GCC601X UC + Networking Convergence Solutions

PBX Firmware Release Notes

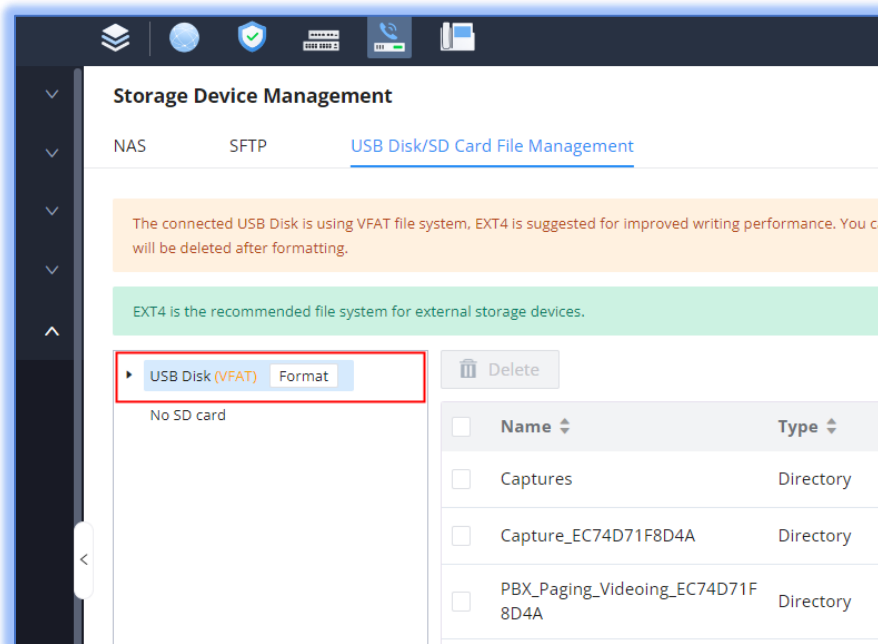
- [File Management] Added ability to format external storage as EXT4 in the *PBX Settings*→*Storage Device Management*→*USB Disk/SD Card File Management* page.
